ADDENDUM NO. 3

Date of Addendum: 2-10-2025

PROJECT NAME: Lake Houston Wilderness Park Cottages

PROJECT NO: WBS No F-HAR014-0001-4-01-01 ; F-HAR014-0001-4-01-02

C5.00
SCALE:

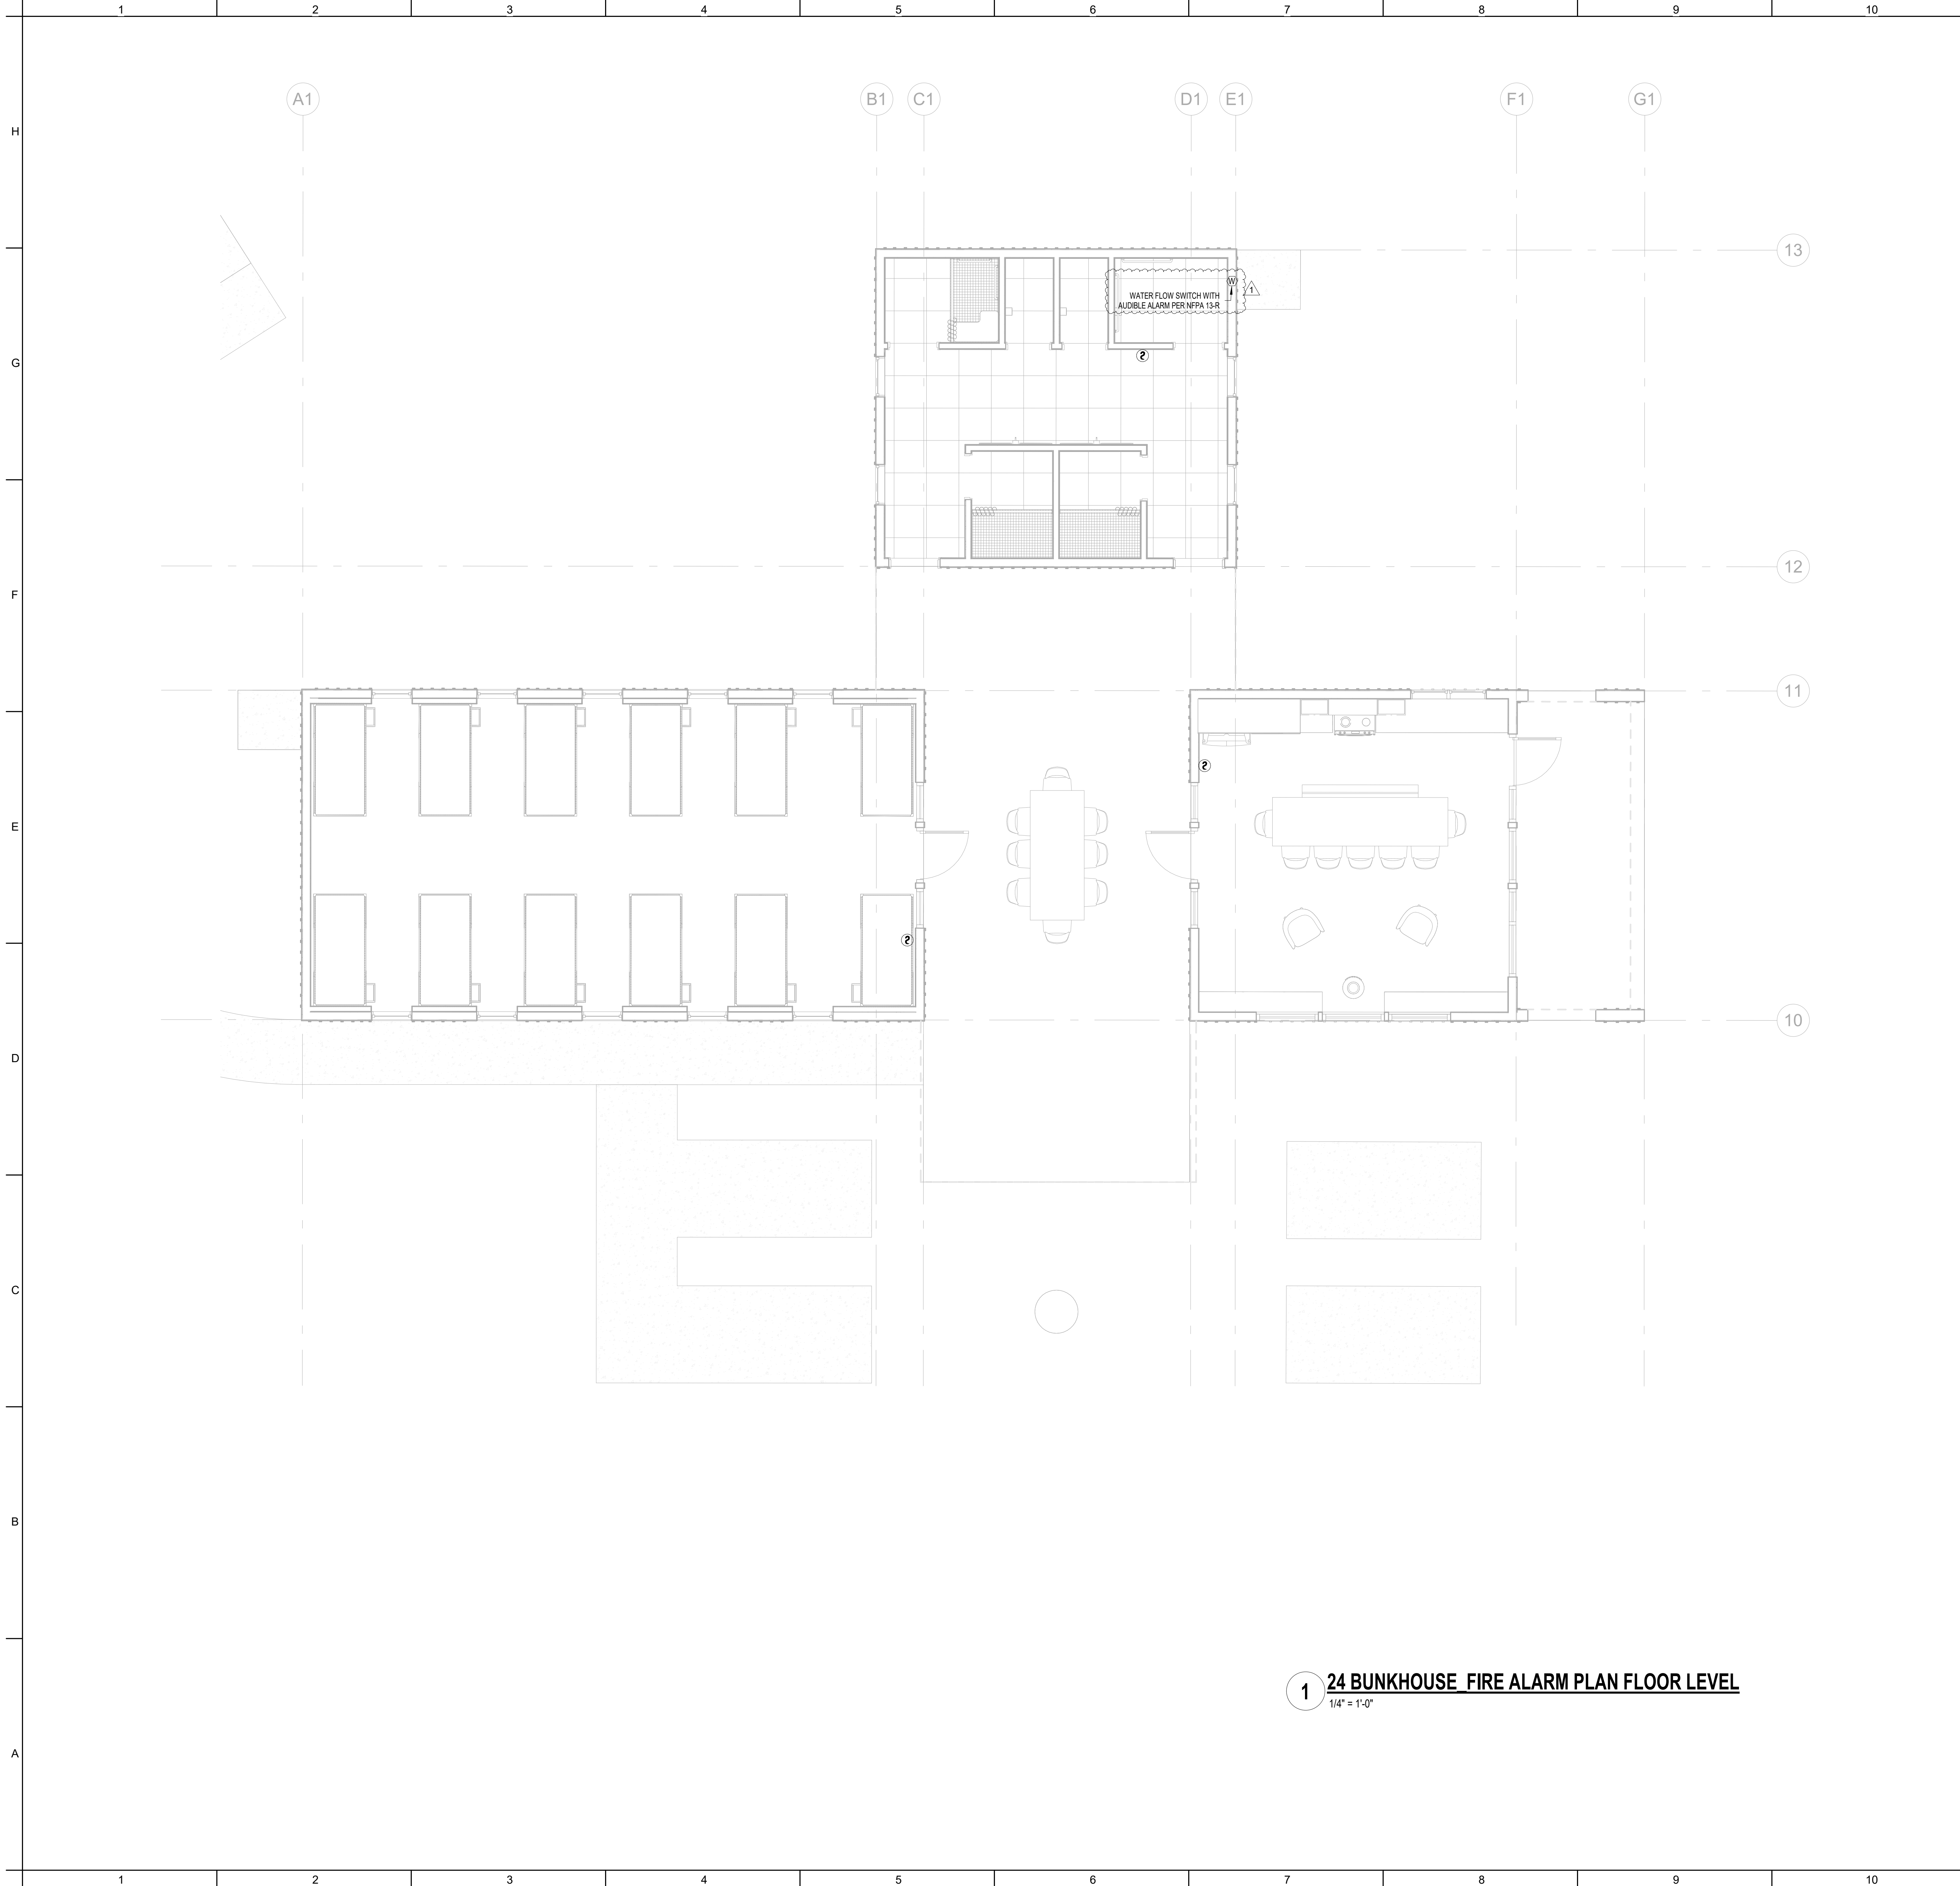
3. G0-06, SITE ACCESS, Add and replace with revised sheet which: Updated site access routes and laydown area per Bidder Site Visit.
4. C5-00 STANDARD PAVING DETAILS, Add and replace with revised sheet which: Added Detail SK-1 for Compacted Crushed Rock for access road per bidder questions referencing Sheet G0-06 note **{Contractor to provide built up stable gravel base for duration of construction for vehicular access}**.

20. Q: Please provide a specification for the Road base for the access drive.
A: See revised Sheet C5-00 STANDARD PAVING DETAILS – detail (SK1_Paving Detail) for paving details regarding the roadway which supplements the previous version of Sheet C5-00.

24. Q: Please provide a detail on materials and how to build up the existing trail road?
A: A paving detail is included in the replacement sheet C5-00 STANDARD PAVING DETAILS – detail (SK1_Paving Detail). You are only to build up the road from the “blocked road” sign to the end of the road where the turnaround is to be created. New replacement Sheet G0-06 SITE ACCESS provides clarification on revised site access. Both replacement drawing sheets are noted in “CHANGES TO DRAWINGS” section above.

F1-01
SCALE: 1/4" = 1'-0"

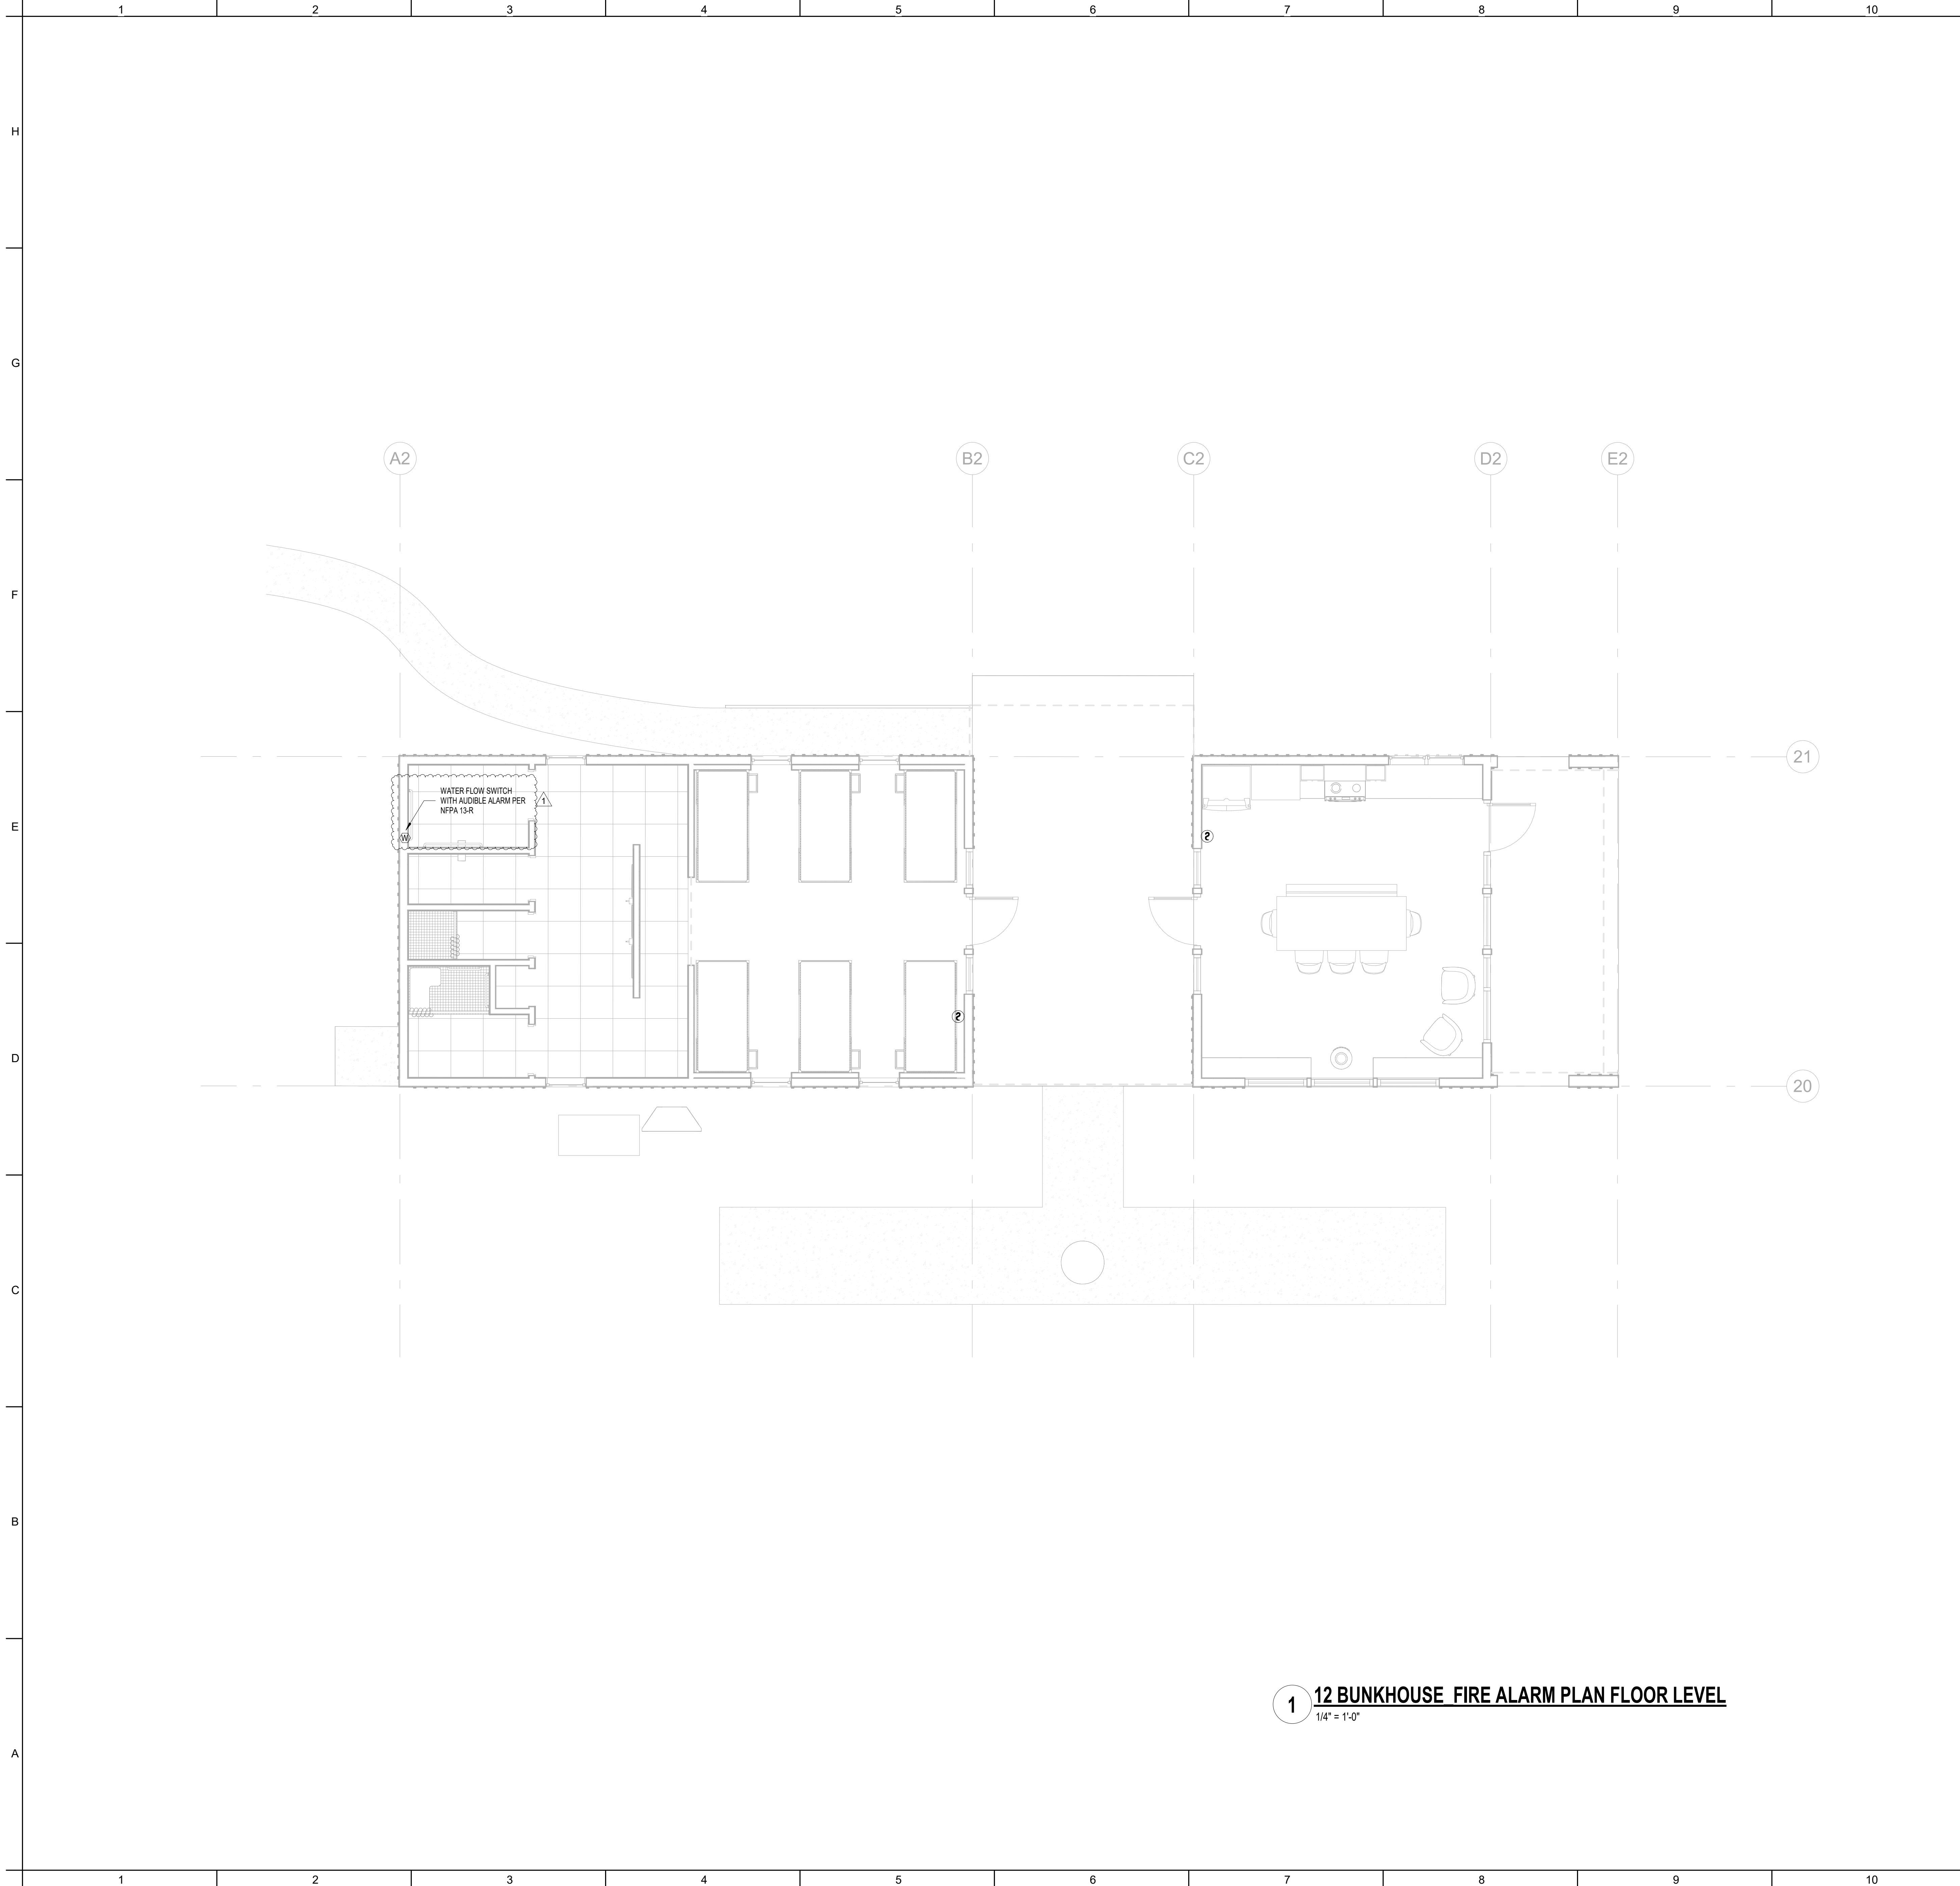
9. F1-01- FIRE ALARM PLAN - #24 BUNKHOUSE, and replace with new version to include additional fire suppression details
10. F1-02- FIRE ALARM PLAN - #12 BUNKHOUSE, Add and replace with new version to include additional fire suppression details
